**REMOVAL OF THE MIDWAY-PACIFIC HIGHWAY COMMUNITY
PLANNING AREA FROM THE COASTAL HEIGHT LIMIT
SAN DIEGO, CALIFORNIA
SCH #2022030324**

FINAL SUPPLEMENTAL ENVIRONMENTAL IMPACT REPORT

Comment Letters and Responses

C7-9

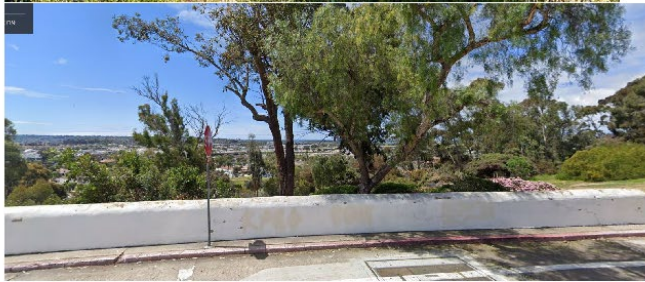
Inadequate views being considered for visual impacts to Presidio Park, Linda Vista, and Bay Park.
